## 3 Proposed design changes

### 3.1 Amendments to motorway-to-motorway interchange at the M7 Motorway

**Figure 3-4** Signalised intersections into the Western Sydney International Airport

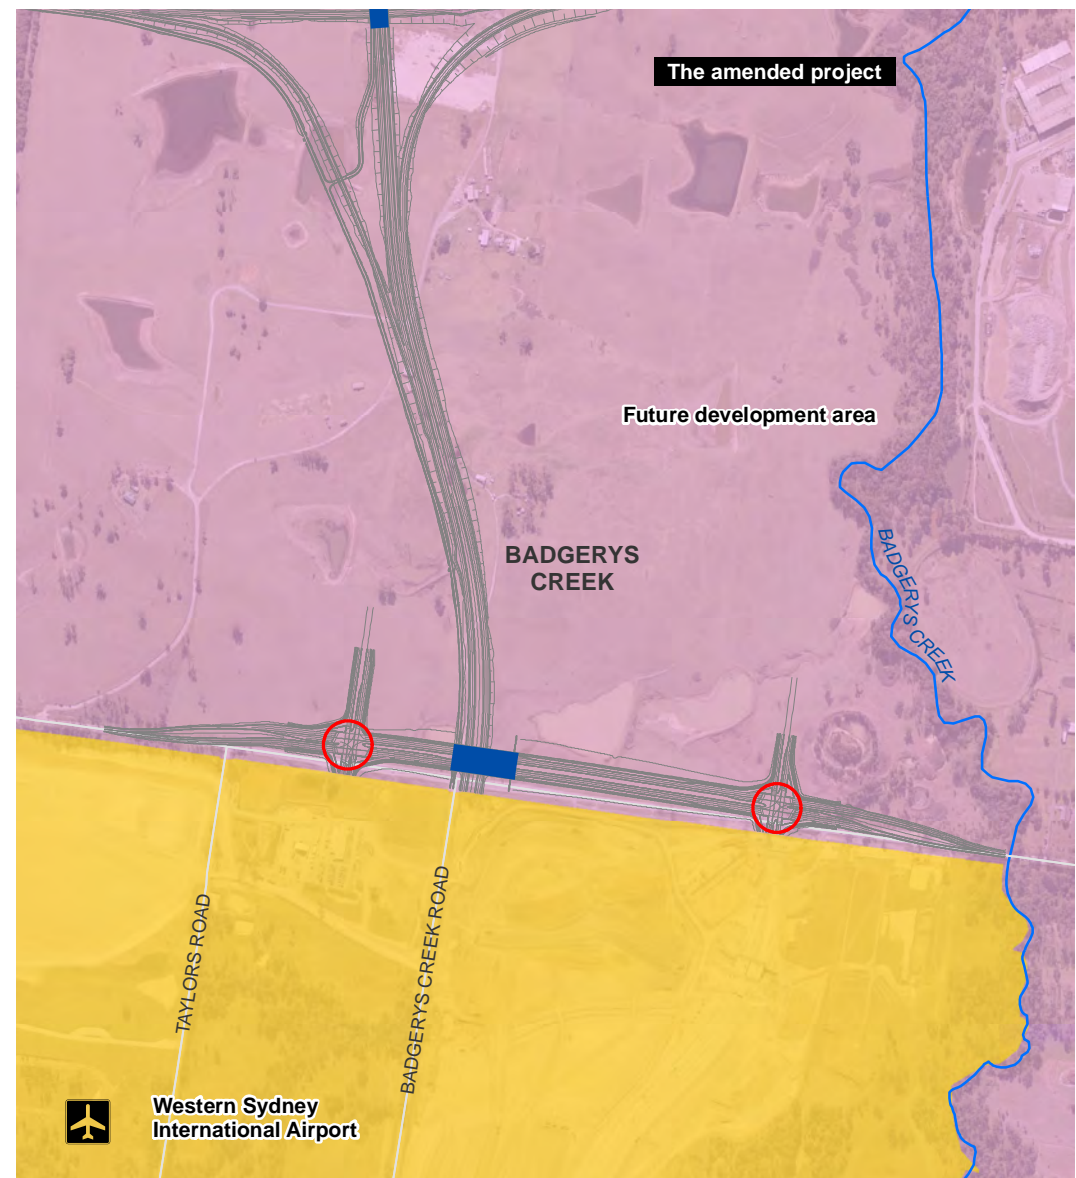
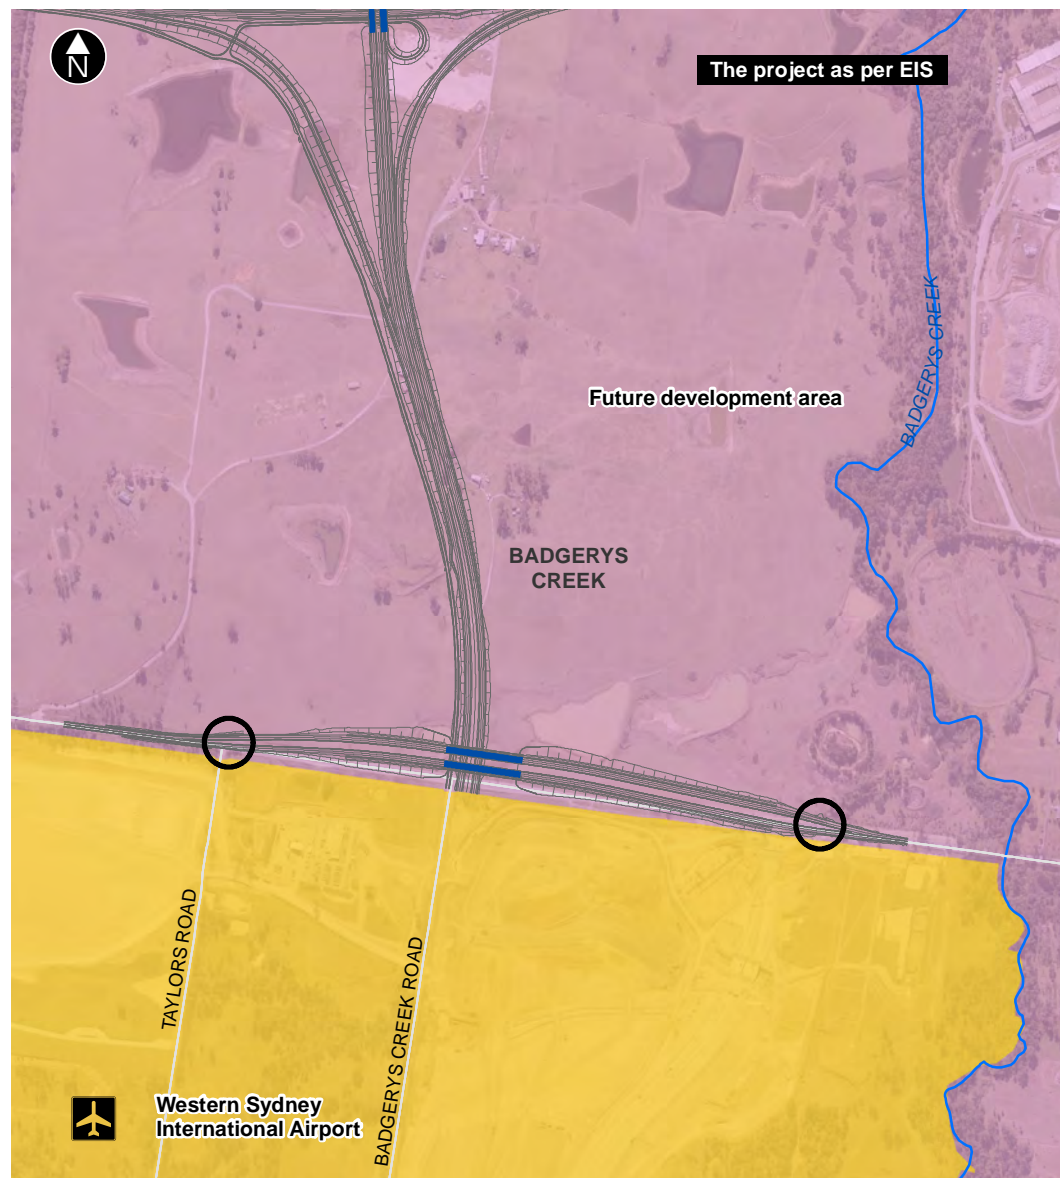
Instead of the signalised intersections from Elizabeth Drive into the Western Sydney International Airport being constructed by WSA Co, the amended project would incorporate the construction and operation of these intersections where funding is available from WSA Co and adjoining developers.

The two new signalised intersections that are proposed subject to funding from WSA Co and adjoining developers as part of the amended project are shown in **Figure 3-4**, alongside the design described in the EIS.

**Figure 3-5** Proposed amended Western Sydney International Airport interchange

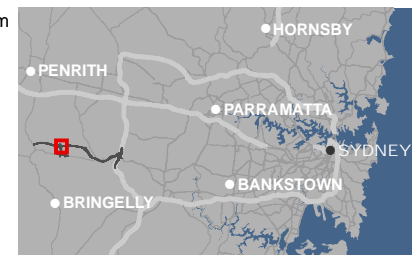
The M12 Motorway at its interchange with the Western Sydney International Airport access road would be lowered by about eight metres when compared to the interchange design as described in the EIS. This design change is in response to further project integration and design development with the Sydney Metro - Western Sydney Airport project (previously known as the Sydney Metro Greater West).

The lowered section of the amended M12 Motorway and the interchange with the airport access road would commence about one kilometre to the west of Bridge 03 and continue to approximately two kilometres to the east of Bridge 03, under passing the proposed Sydney Metro - Western Sydney Airport approximately 500 metres to the east of Bridge 03. The proposed amended Western Sydney International Airport interchange is shown in **Figure 3-5**.

- Optimisation of the vertical alignment of the M12 Motorway between Luddenham Road and Badgerys Creek
- Reduction in height, total fill material (see **Table 4-3**) and construction materials required for Bridge 03 and associated entry and exit ramps
- Reduction in construction heavy vehicle movements and maximisation of construction efficiency due to the reduction in total fill material and construction materials required (see **Section 4.2.6**).

**Figure 3-6** Proposed amended shared user path alignment

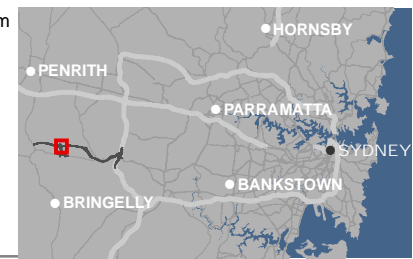
In order to facilitate the lowering of the Western Sydney International Airport interchange, the alignment of the shared user path would also need to be altered. The proposed shared user path for the amended project would underpass the M12 Motorway westbound entry ramp from the airport access road about 300 metres further south than in the design described in the EIS. From this underpass, the shared user path would travel north along the western side of the Western Sydney International Airport access road, bridging over the M12 Motorway and forming a loop to decrease in elevation and continue along the northern side of the M12 Motorway as far as Clifton Avenue.

The amended shared user path alignment is shown in **Figure 3-6**.

**Figure 3-7** Amended operational footprint

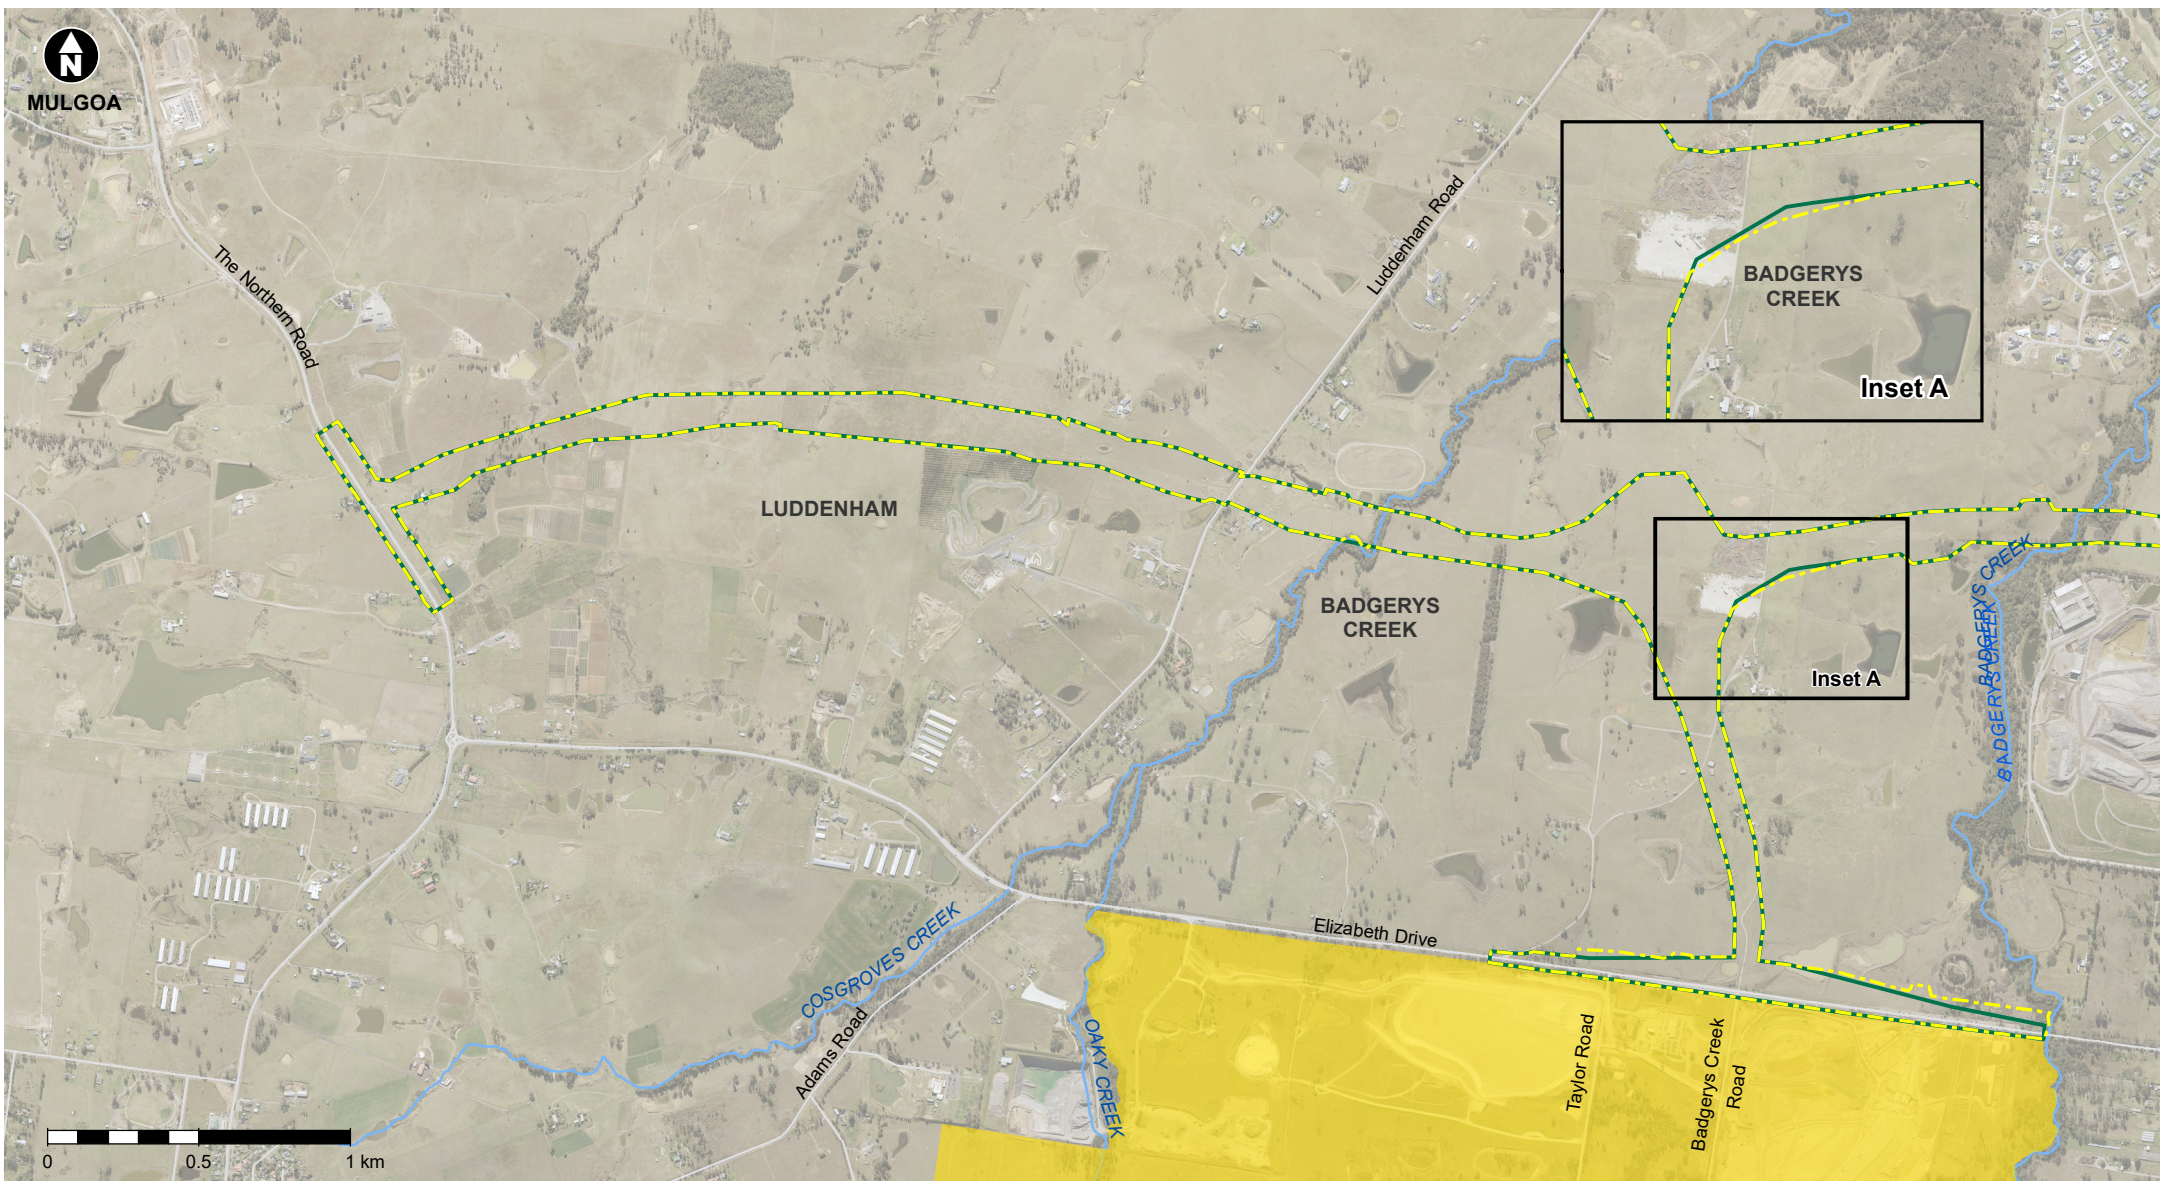
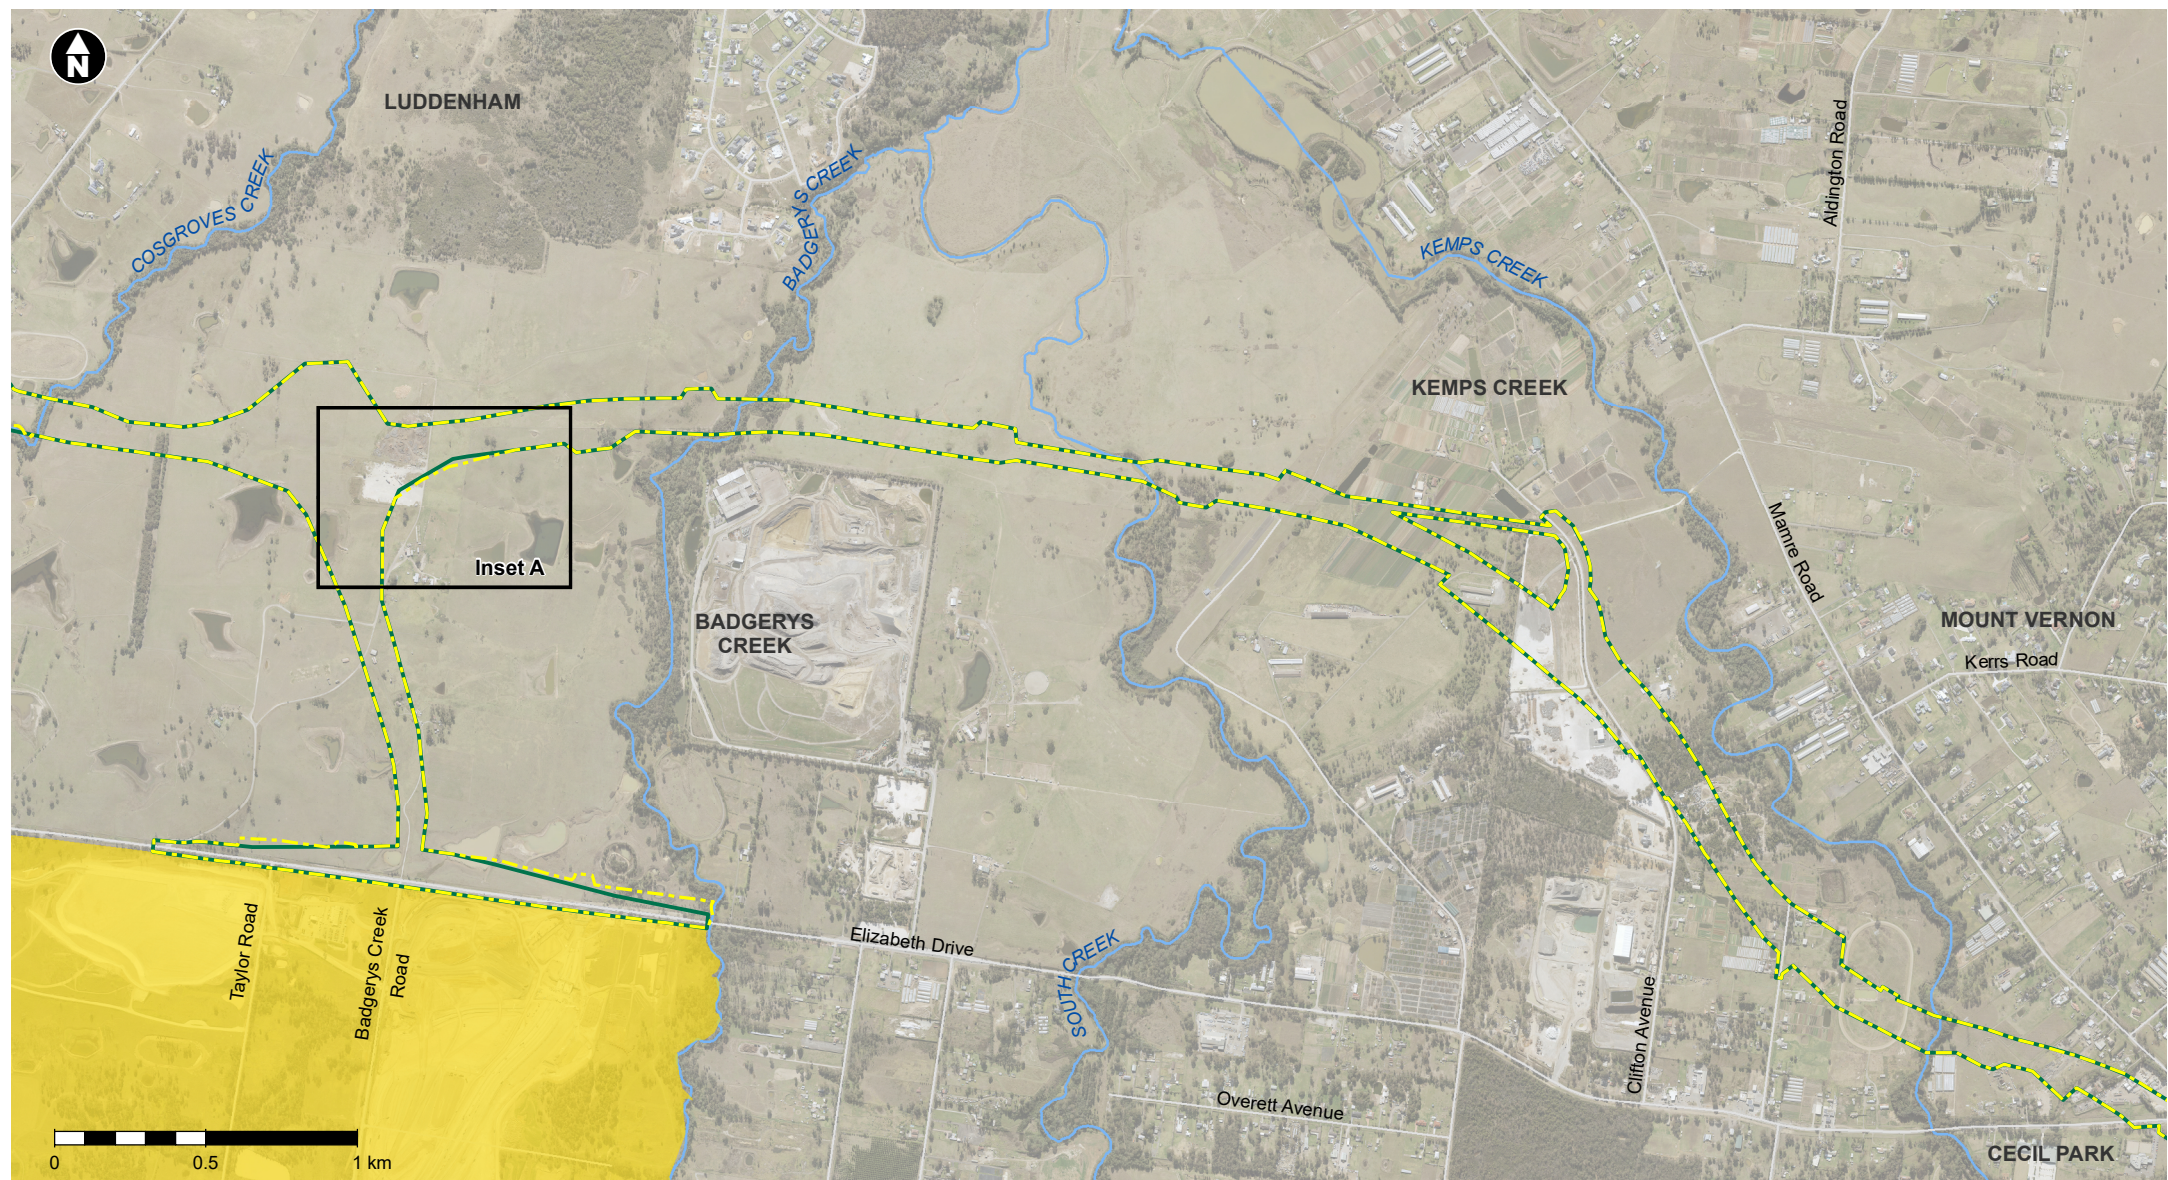
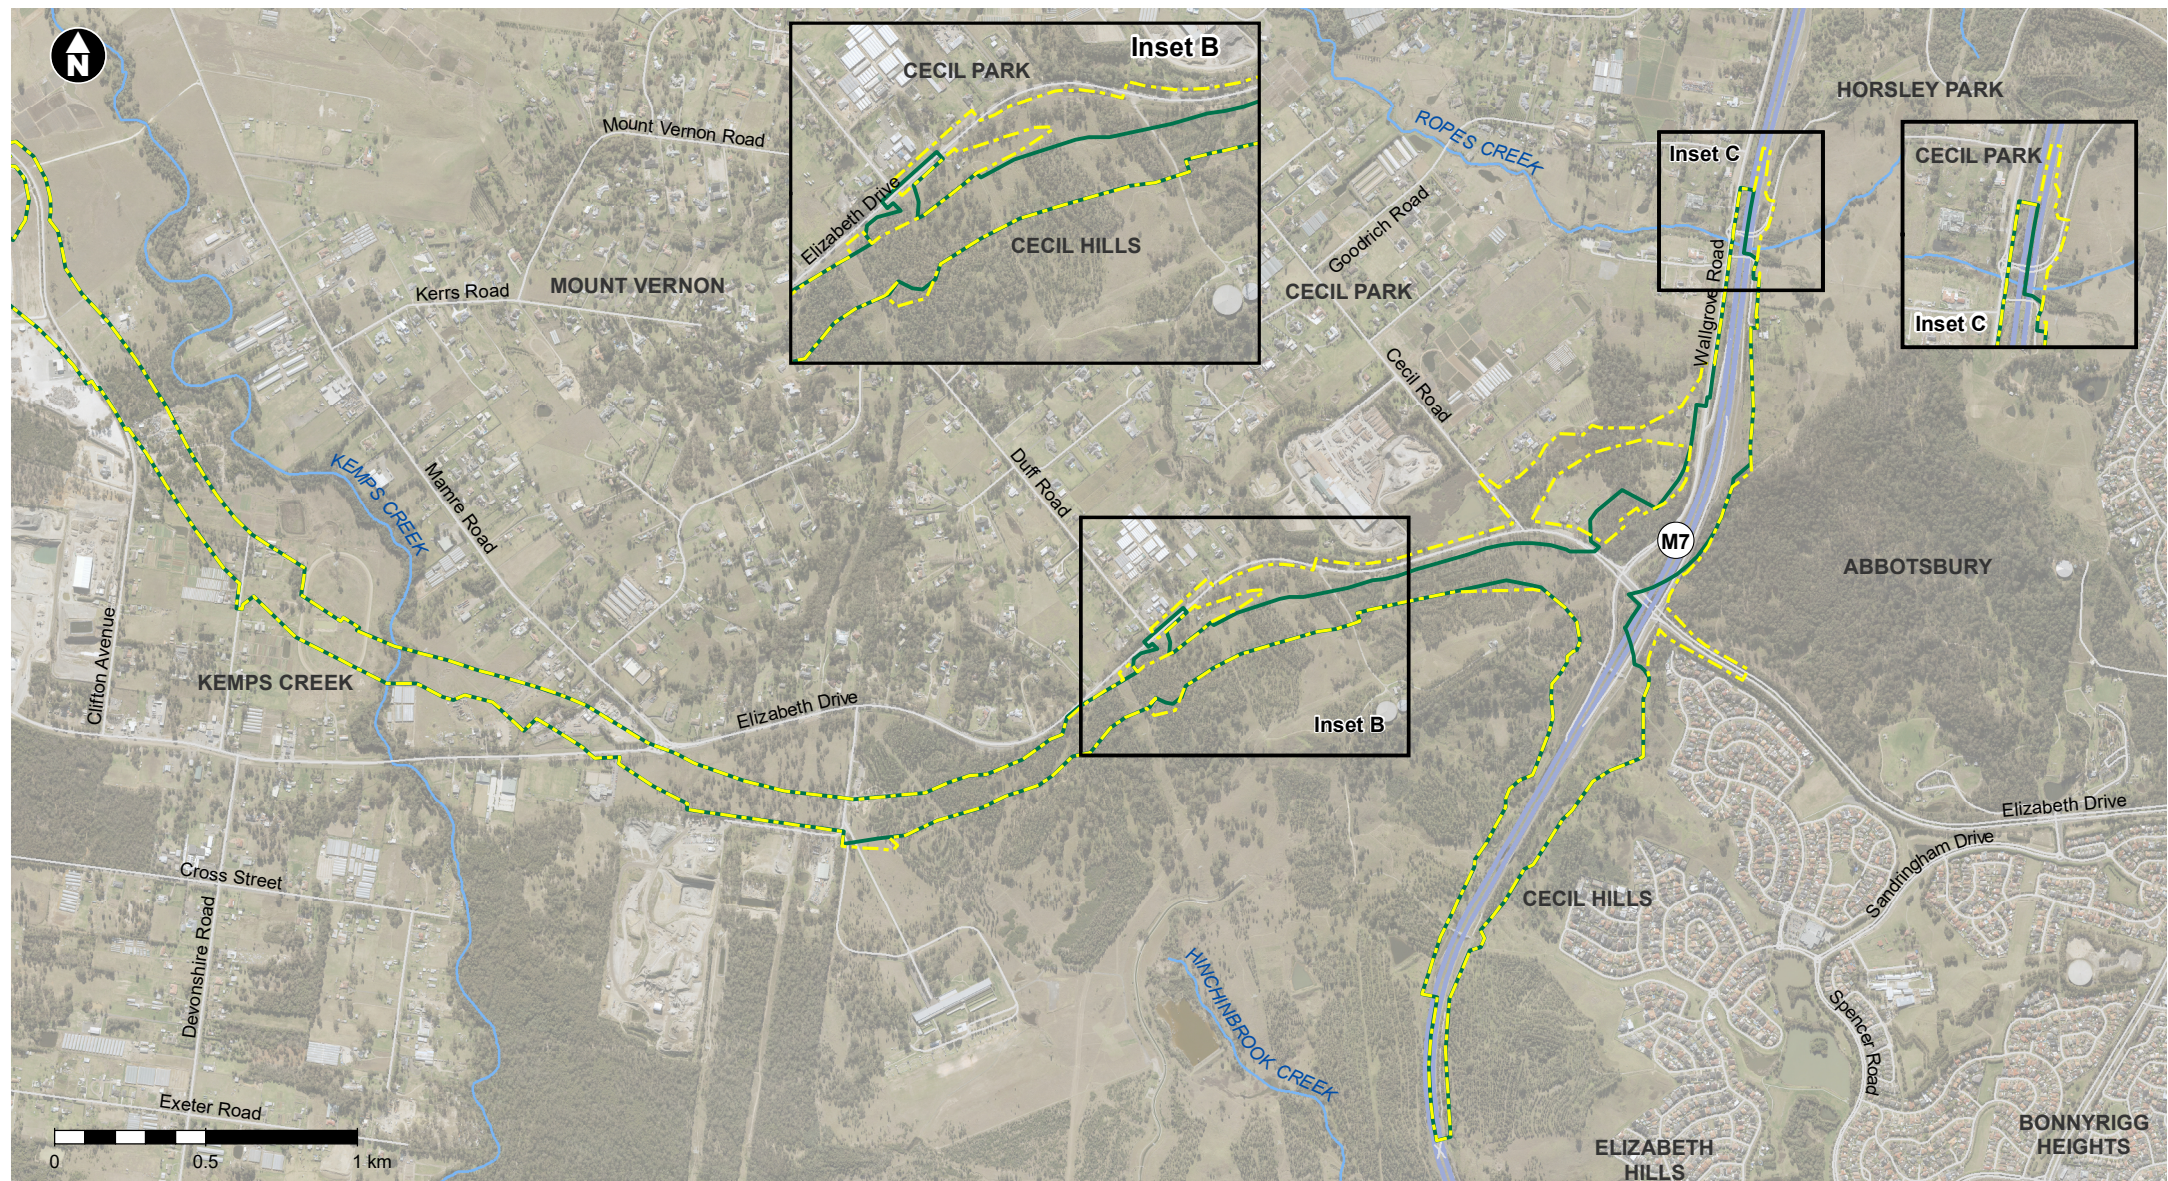
This updated footprint is referred to as the amended operational footprint and would comprise about 317 hectares. This is an increase of about 32 hectares. Both the amended operational footprint and the operational footprint as described in the EIS are shown in **Figure 3-7** for ease of comparison.
